Memorandum
Planning and Urban Development Department
Planning Division

Re: MMC East Tower and Visitor Garage Vertical Expansion
 22 Bramhall Street
 Maine Medical Center (MMC)

Project #: 2017-289 CBL: 053D007/054H001/064C001

Meeting Date: February 27, 2018 (Second Workshop)

Proposed, comparable rendering (see WSQ – 1)

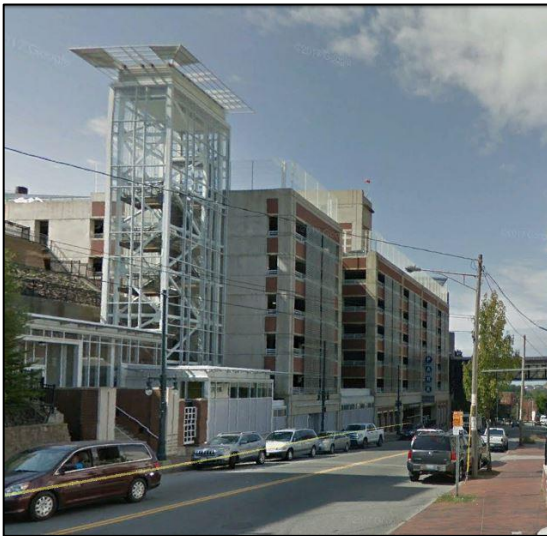
East Tower: Addition of two floors (64 patient rooms, single-occupancy):

- **East Tower:** *Staff, aligned with PB comment, continue to have some concern about the facade integration of the new and existing - especially in overall facade composition, proportion, and articulation. The existing building has a high level of articulation while the proposed new is much more minimal. Please clarify where new metal panel is proposed and where existing to remain and the strategy around getting those to match or blend. Staff suggest you consider articulation strategies in the new section that address these integration concerns whether that is a horizontal band, dimensional elements, color or other strategies.*
- **Garage:** *There are two opportunities to update or improve the design character of the garage - the fall protection fence, especially on the top level, and the metal screens.*

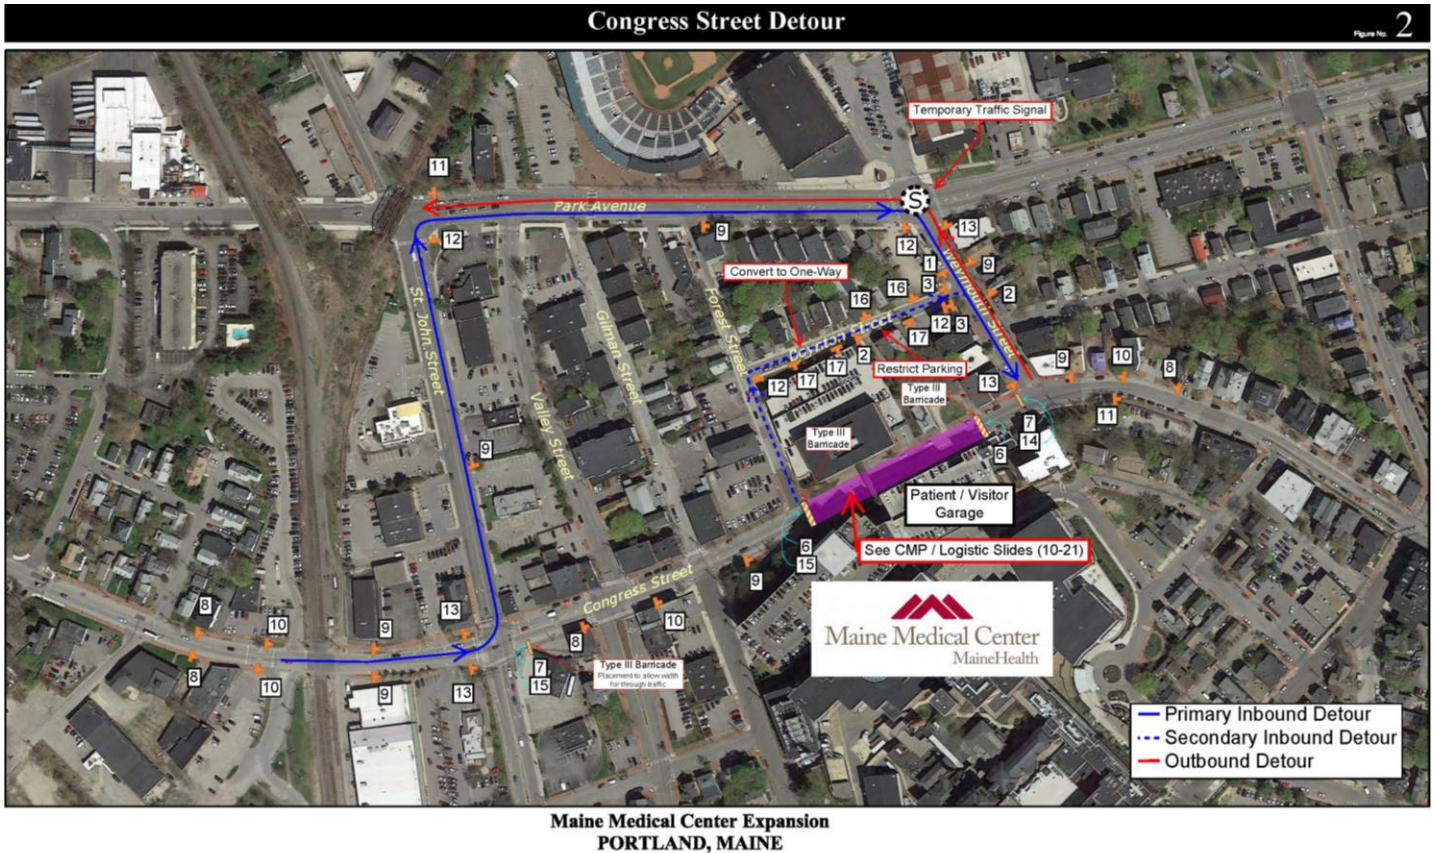
d. *Traffic Control/ Detours and associated signage, signals and parking restrictions (See Plan GP Traffic Analysis)*

The Turner CMP discussed above has addressed the need for some parking and traffic restrictions plus signage on the local streets near the East Tower construction site, and these are shown in the graphics referenced above.
